From: [Appel, Patrick](#)
To: [Coltrain, Katrina](#)
Subject: RE: Field maps 11-SW_Sediment, 8-Soil_Lorraine, 9-Soil_Wilcox_2, 10-Soil-ETF_Background
Date: Thursday, October 13, 2016 1:39:48 PM
Attachments: [image001.png](#)
[11-SW_Sediment.pdf](#)

Subject: RE: Field maps 11-SW_Sediment, 8-Soil_Lorraine, 9-Soil_Wilcox_2, 10-Soil-ETF_Background

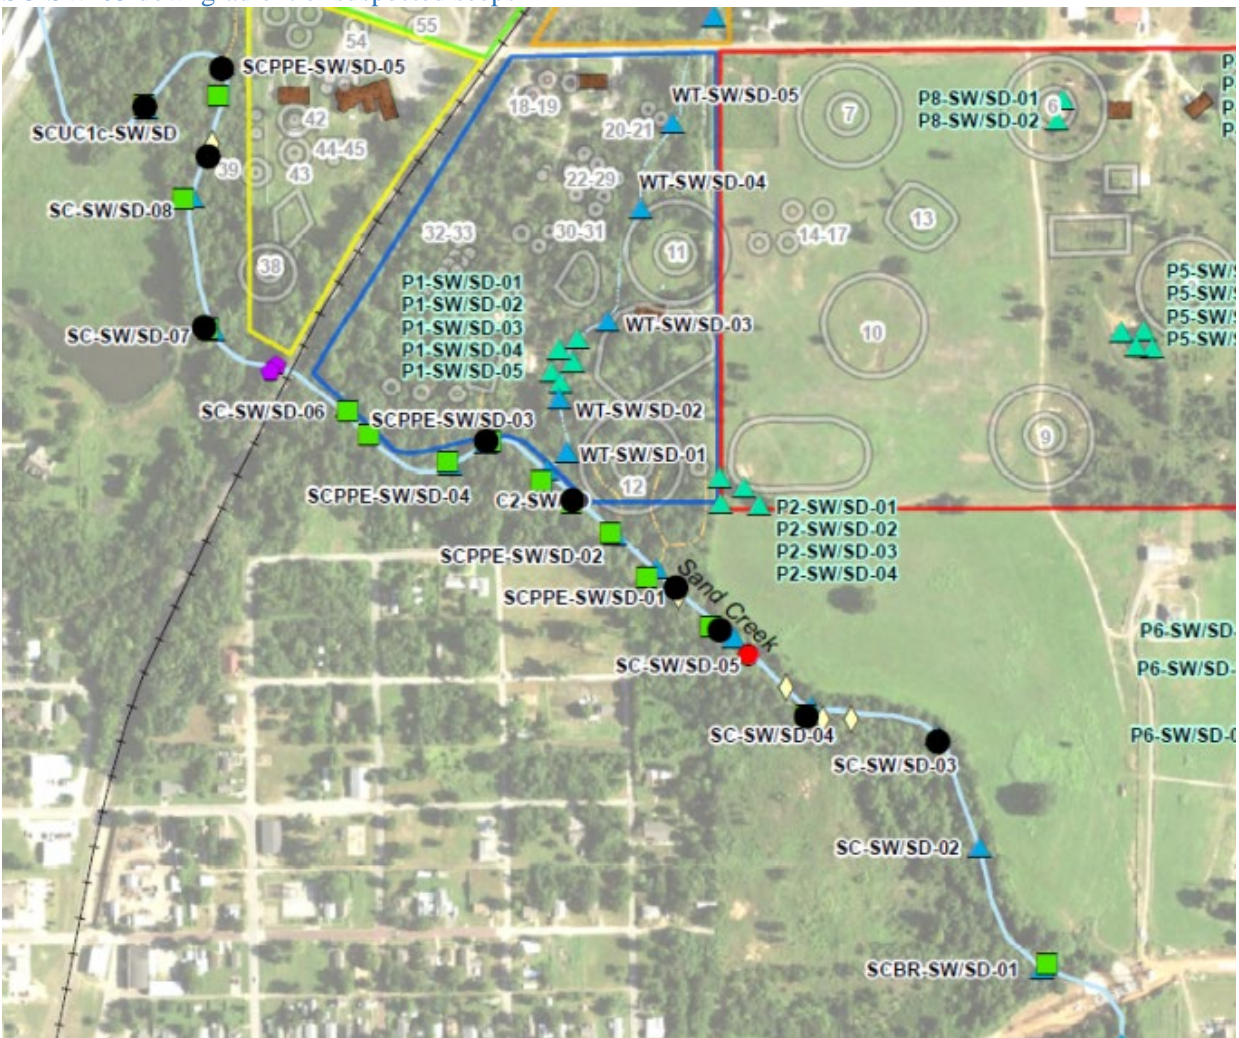
Pat, here are the locations I am thinking about.

SCUC1c-SW upgradient

SCPPE-SW-05 tributary

SC-SW-08 adjust to location of suspected seep

SC-SW-07 downgradient of seep

SCPPE-SW-03 tributary from lead sweetening area

C2-SW tributary across the site/connection with pond

SCPPE-SW-01 adjust to location of suspected seep

SC-SW-05 adjust to location of piping

SC-SW-04 adjust to location of suspected seep

SC-SW-03 downgradient of suspected seeps

Katrina – here is a revised map of the locations.
